Access Compliance Report

Public Rights-of-Way

Intersection ID: 10022610	Main Street: CARMEL_RD	Cross Street: N/A	Location: N
ADA ID: D7F62747CEC2	Ramp Type: PerpDiag	Initial Pass/Fail: Fail	Overall Compliance: No
		Severity Score: 25

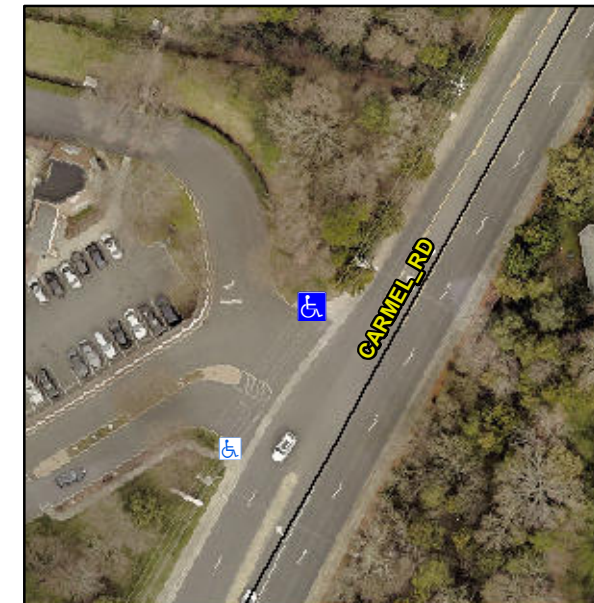
R304.2.2, R304.5.3

Compliance	Description	Data	Compliance	Description	Data
N/A	Ramp Length (in)	59.0	No	Ramp Slope (%)	9.7
Yes	Ramp Width (in)	48.0	No	Ramp XSlope (%)	6.1
N/A	Flare Type LT	N/A	N/A	Flare Type RT	N/A
N/A	Flare Slope LT (%)	N/A	N/A	Flare Slope RT (%)	N/A
N/A	Flare Traversable LT?	N/A	N/A	Flare Traversable RT?	N/A
N/A	Landing Length (in)	N/A	N/A	DWS Provided?	N/A
N/A	Landing Width (in)	N/A	N/A	DWS Contrast?	N/A
N/A	Landing Slope (%)	N/A	N/A	DWS Length (in)	N/A
N/A	Landing X Slope (%)	N/A	N/A	DWS Full Width?	N/A
N/A	Landing Curb? (Y/N)	N/A	N/A	DWS Offset (in)	N/A
N/A	Shared Landing?	N/A			
N/A	Gutter Ponding?	N/A	N/A	Gutter Slope (%)	N/A
N/A	Gutter Lip Ht (in)	N/A	N/A	Gutter X Slope (%)	N/A
N/A	Painted X Walk1?	No	N/A	Painted X Walk2?	No
	X Walk 1 Direction	To SW		X Walk 2 Direction	To SE
N/A	X Walk 1 Width (in)	N/A	N/A	X Walk 2 Width (in)	N/A
	X Walk 1 Slope (%)	3.5		X Walk 2 Slope (%)	5.8
	X Walk 1 X Slope (%)	6.6		X Walk 2 X Slope (%)	1.7

Remove & Replace Curb Ramp With Two New Directional Ramps or Equivalent.
